# Section 96(1a) Modification Application

Proposed Modifications to a Six Storey  
Commercial Building with Two Storey Basement  
Car Park, Associated  
Plant and Subdivision of Lot 8C

9 Murray Rose Avenue (Site 8C),  
Sydney Olympic Park

Application Number: SSD 13\_6059

**Figure 3.1:** 3D Model of Approved Southern Façade (SSD 13\_6059)

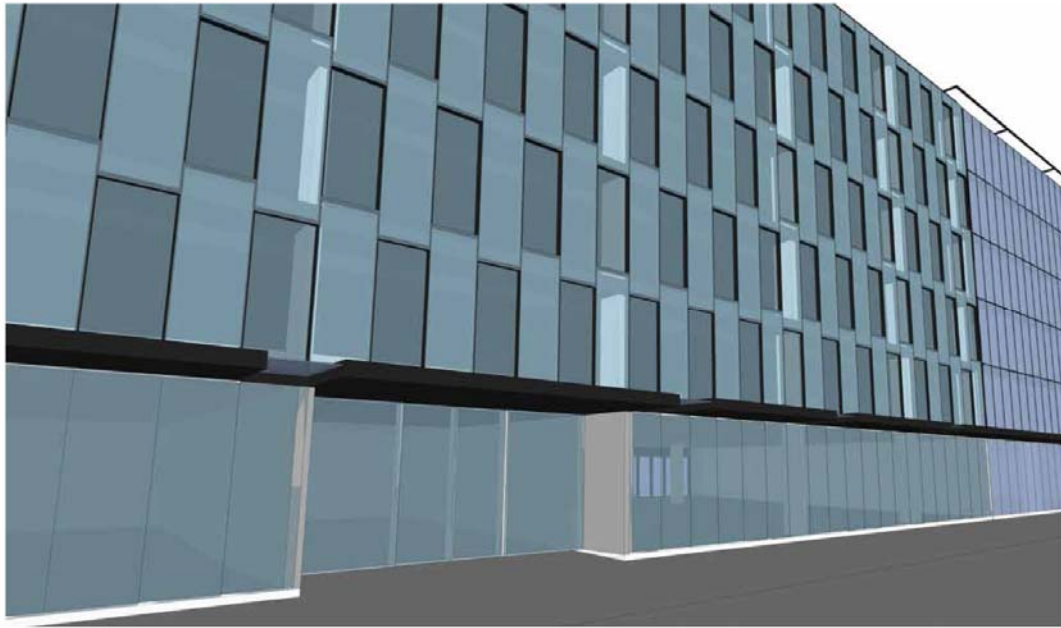
The proposed modification involves maintaining the characteristics of the approved façade but including additional architectural glass blades to mullions to further articulate the façade and create visual interest for the building and streetscape.

NRMA propose to further accentuate the building entry by recessing the façade (by approximately 1200mm) to the ground, first and second floor as illustrated in *Figure 3.2*. The façade within the proposed recess will be simplified to include larger glazed panels with subtle joints and colour back glazed spandrels to slab edges.

NRMA propose to install building identification signage as illustrated below involving an illuminated sign mounted on the façade.
